**No. 96-8**

## Belt Driven Seawater Pump ( With Plastic Body ) Changes.

### Models

All MCM, MIE models with Belt Driven Seawater Pump with plastic body.

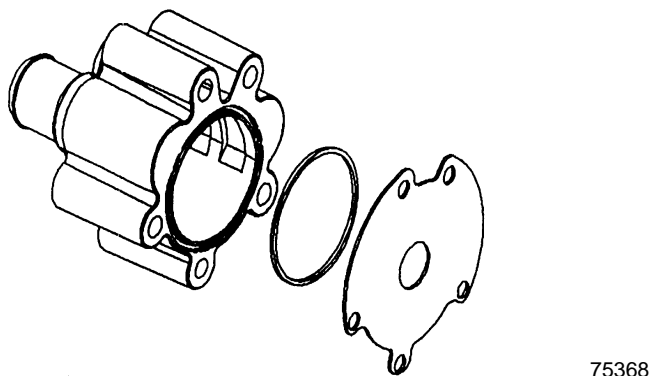
The original pump has been called the 2-piece body because it used a cover with gaskets and a wear plate.

A 1-piece body is now used in production and is available for servicing most of the older seawater pumps with the 2-piece body. This new 1-piece body gives 20% more water flow at higher engine RPM's than the older 2- piece pump and it eliminates 2 gaskets, 1 wear plate and the cover.

Replacement body, P/N 47-72774A40, for the 2-piece body pump has been made No Longer Available. To help you service both body types of seawater pumps, several kits have been made available. These kits and their use are listed on the reverse side.
